In the matter of an application by **Dunedin City Council** for resource consents for the operation, closure and aftercare of the Green Island Landfill, Dunedin.

Statement of evidence of Simonne Frances Eldridge

On behalf of Dunedin City Council

4 March 2025

CLIENT	DUNEDIN CITY COUNCIL
PROJECT	LANDFILL GAS RISK ASSESSMENT
TITLE	LANDFILL GAS CONCEPTUAL CROSS SECTIONS
SCALE (A1)	1:500
FIG No.	1008787-F11
REV	0

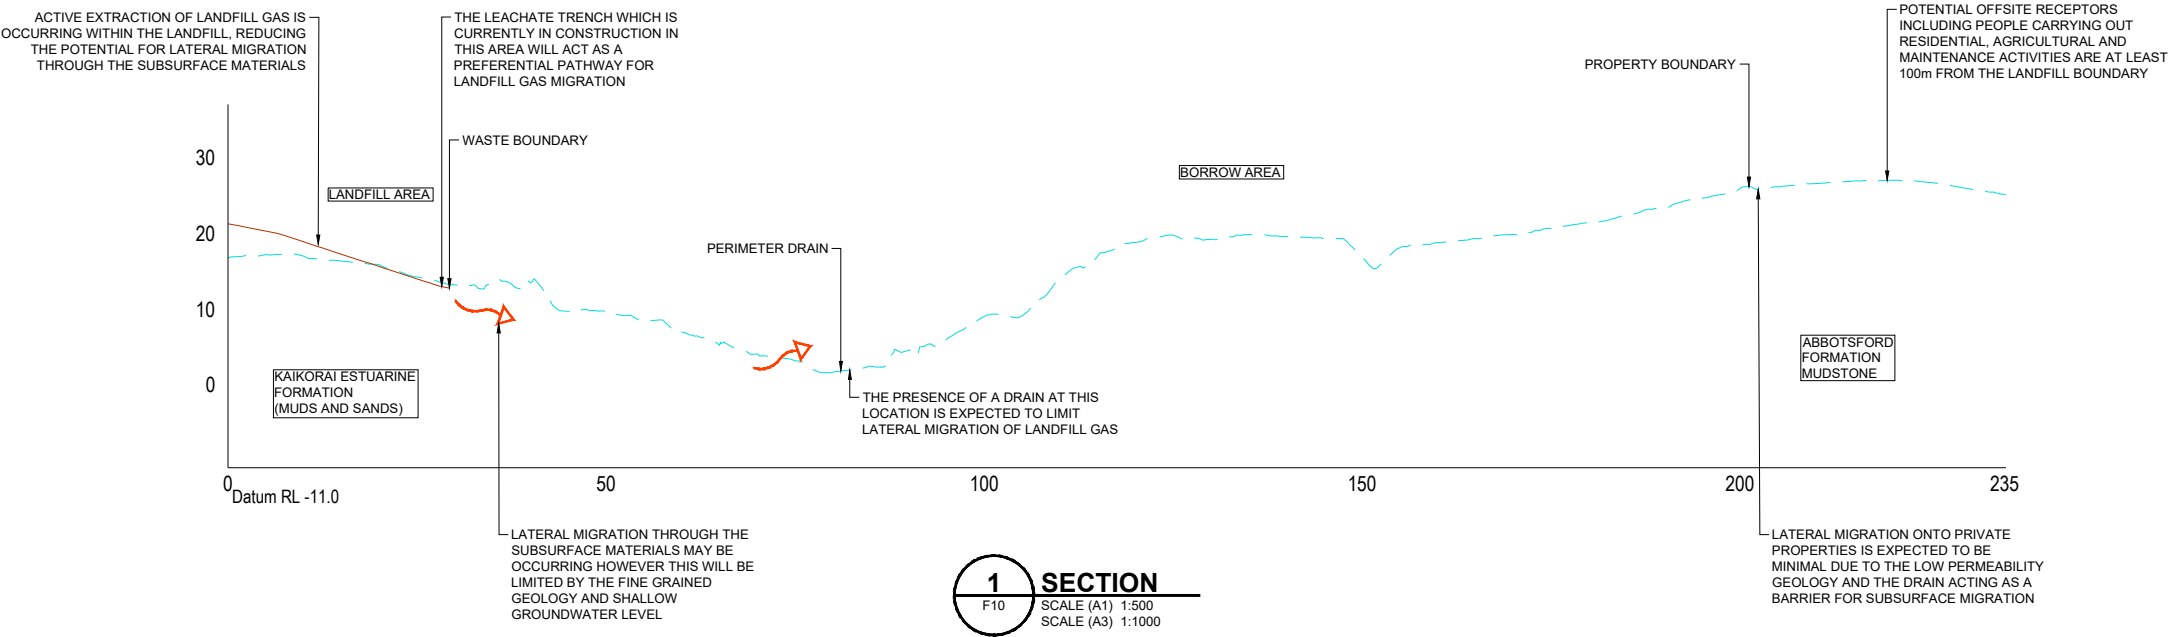
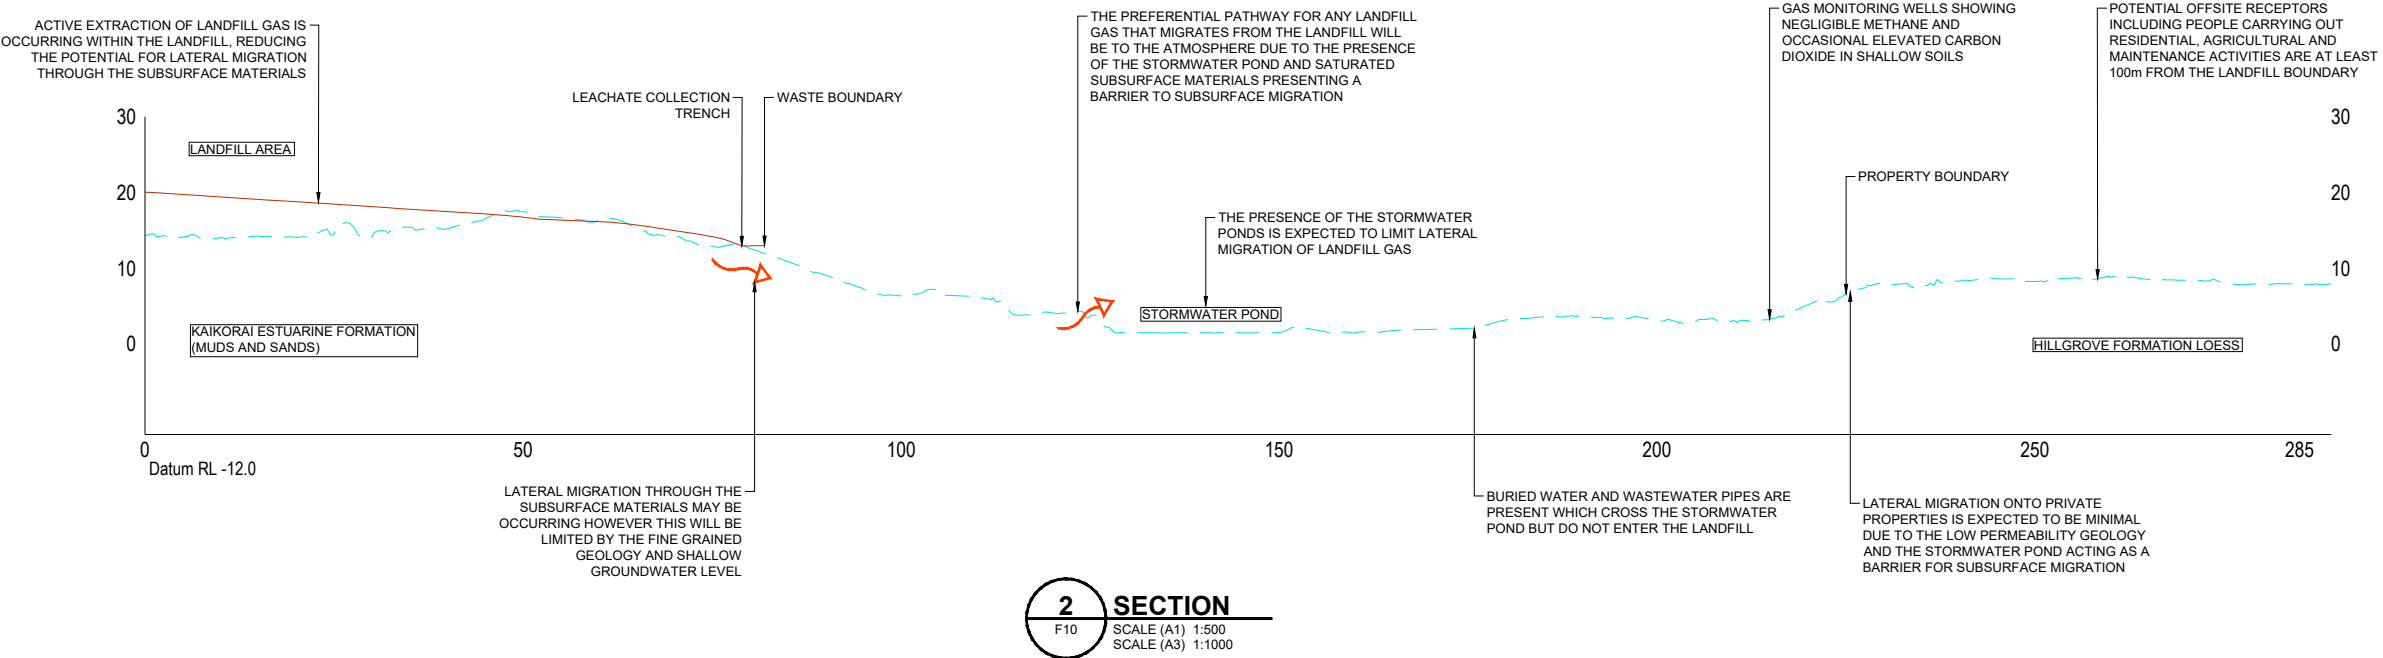
- 29 **Paragraph 69:** Noted and agree is a reflection of the LFGRA conclusion.
- 30 **Paragraph 70:** The LFGRA was prepared in response to a Section 92 request from Mr Elliot⁹ which raised the potential for environmental impacts of subsurface landfill gas migration with specific reference to surrounding geology and buried services. I note the following in response to Mr Elliott's questions:

- (b) A plan showing the landfill gas monitoring wells and two conceptual cross sections is attached in relation to potential receptors to the east and southeast of the site respectively.
